**RE: Sundance Construction – Beverly Hills
Grading and Drainage Plan
Engineer’s Stamp Date: 01/24/18
Hydrology File: B18D023**

Based upon the information provided in your submittal received 01/24/18, the Grading and Drainage Plan **is not** approved for Building Permit. The following comments need to be addressed for approval of the above referenced project:

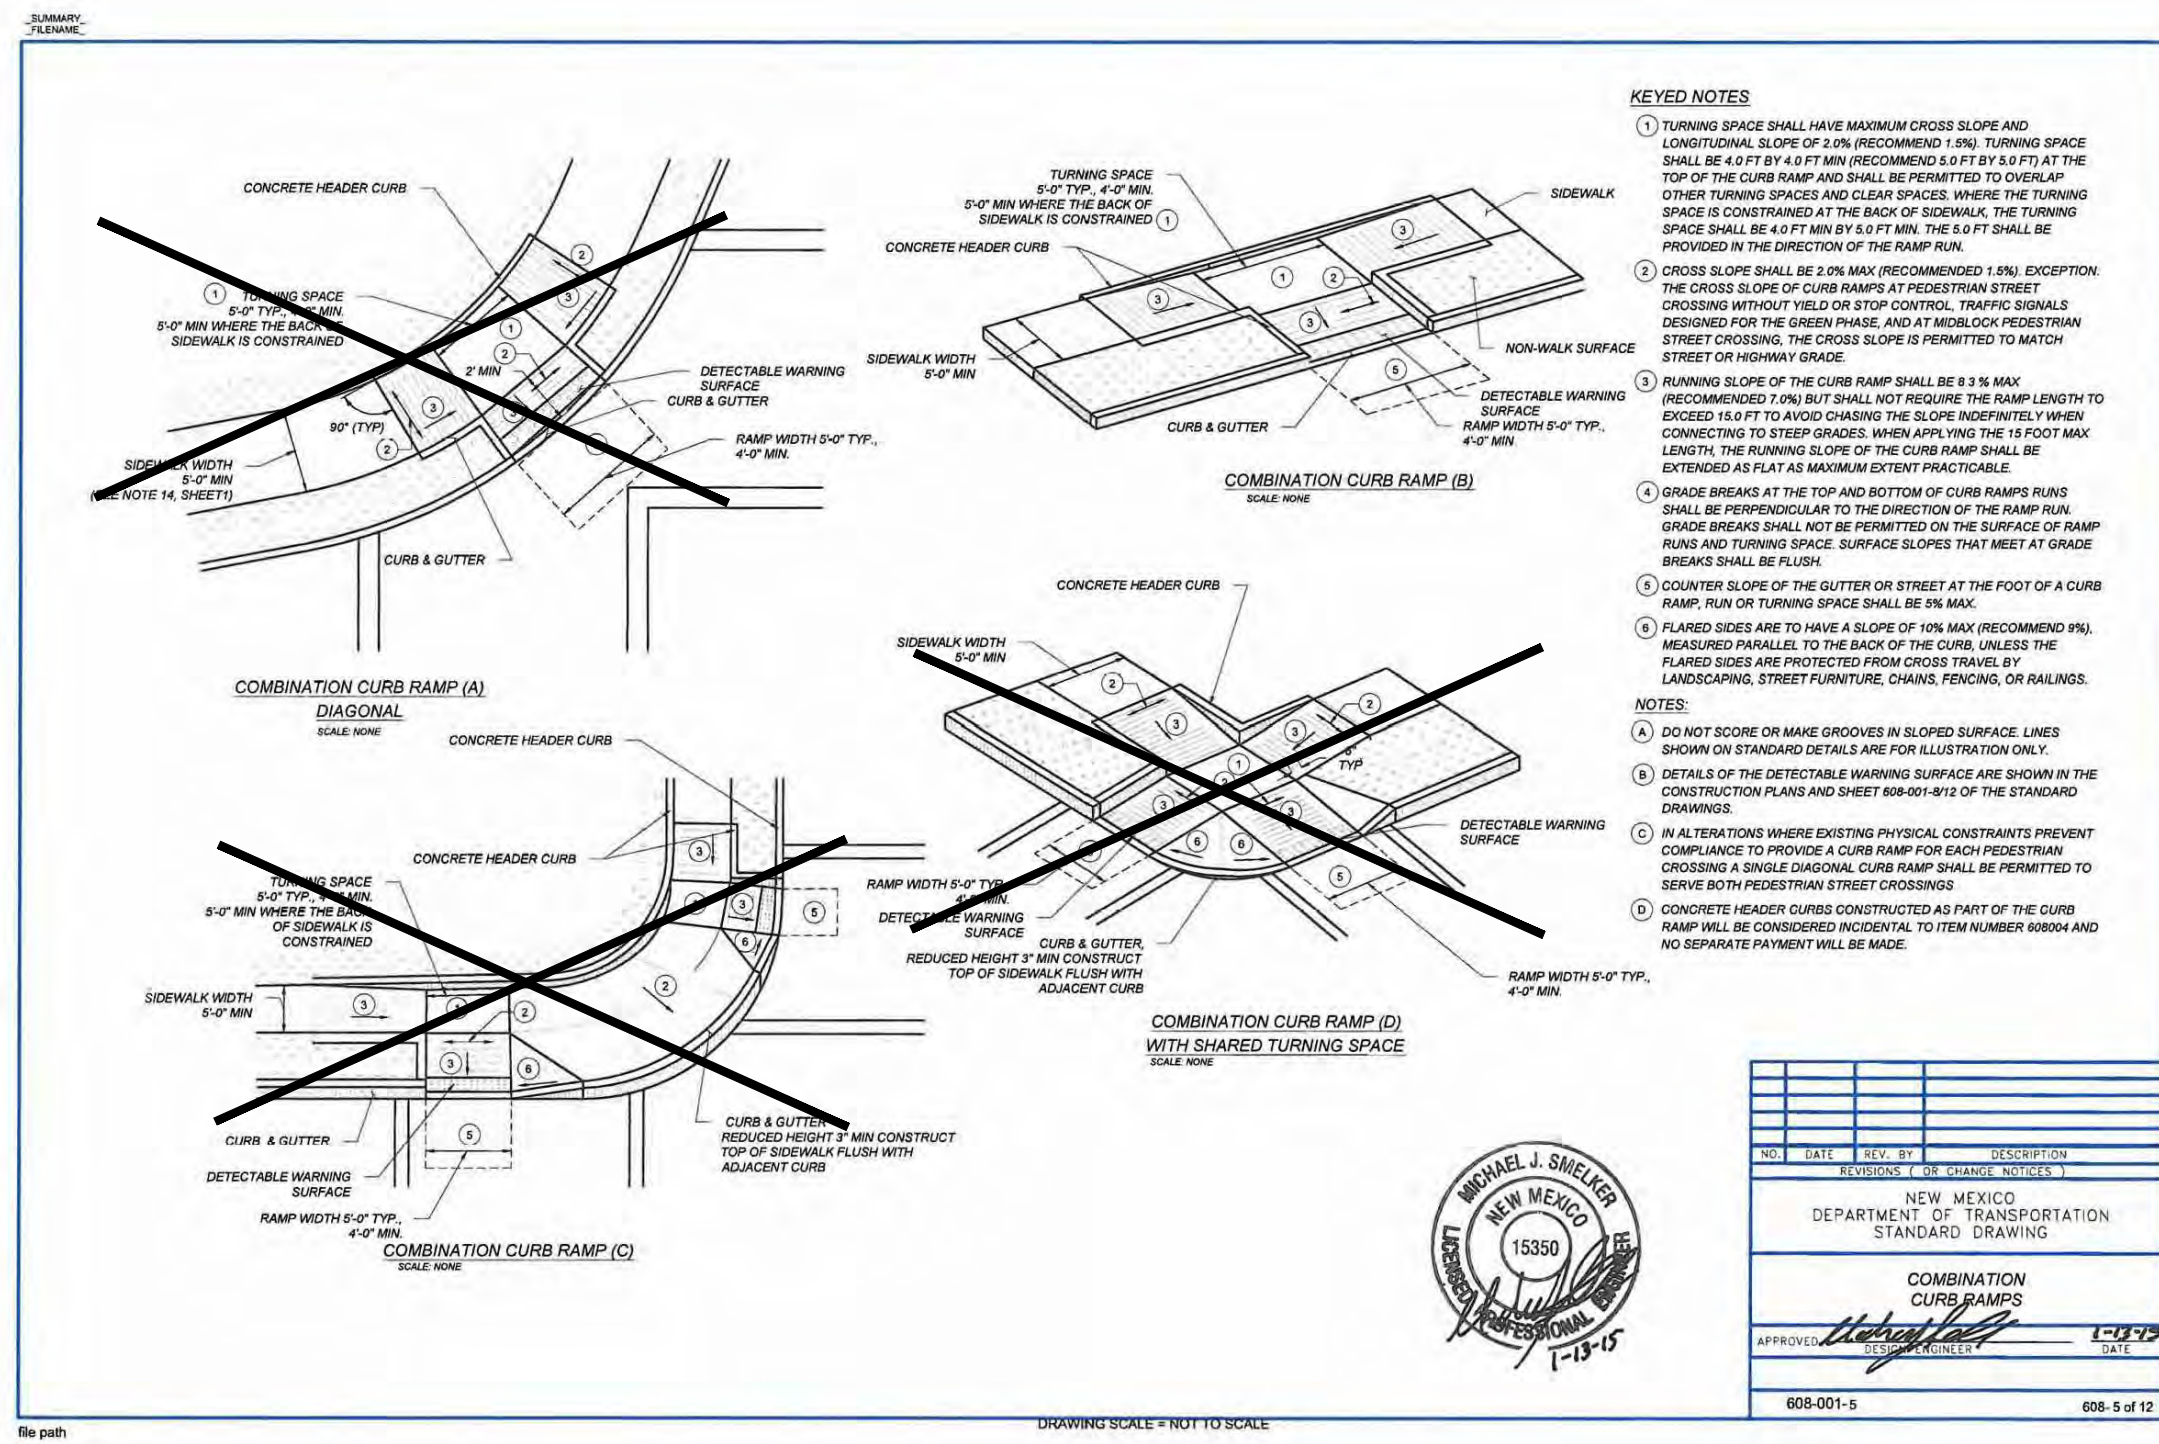
9. Sheet C-501. Where is the typical pond section detail used? If not needed, then please just delete.
